ATTACHMENT 3

PROPOSED TECHNICAL SPECIFICATIONS

Marked up Technical Specification Pages;

TURKEY POINT - UNITS 3 & 4

FIGURE 2.1-1
REACTOR CORE SAFETY LIMIT - THREE LOOPS IN OPERATION

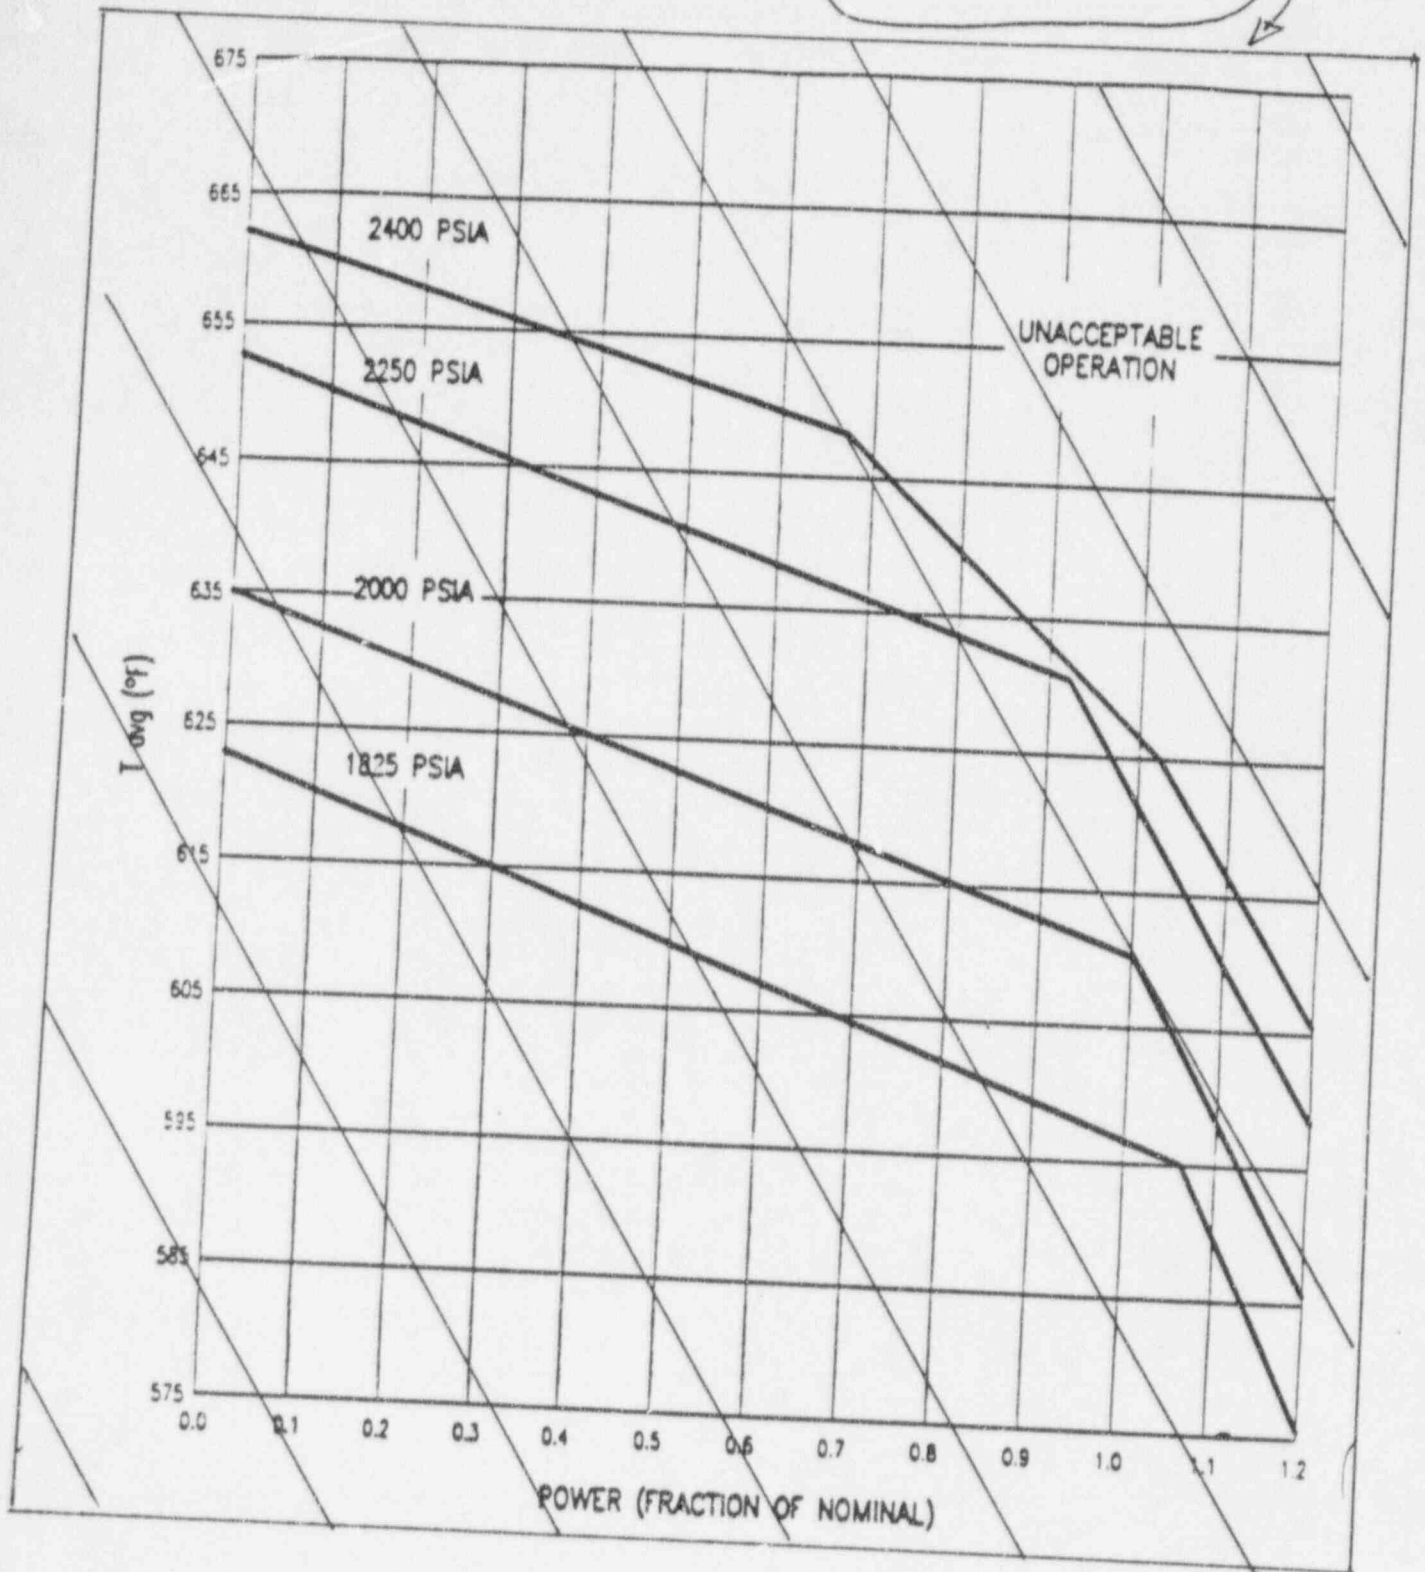
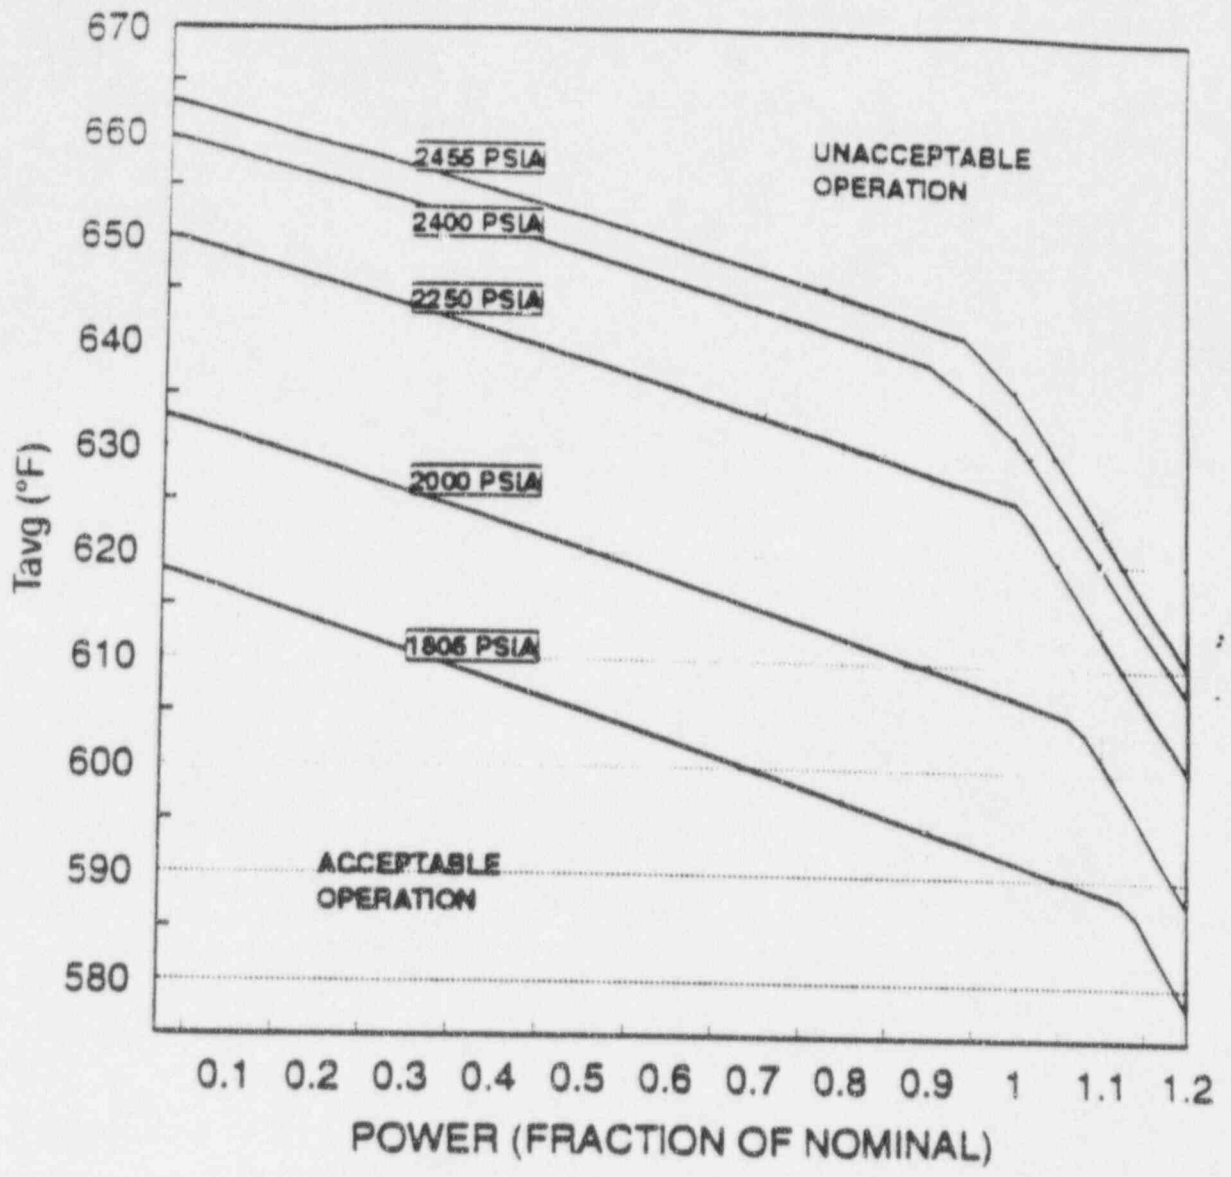
INSERT 'A' HERE

INSERT A

Figure 2.1-1
Reactor Core Safety Limit - Three Loops in Operation
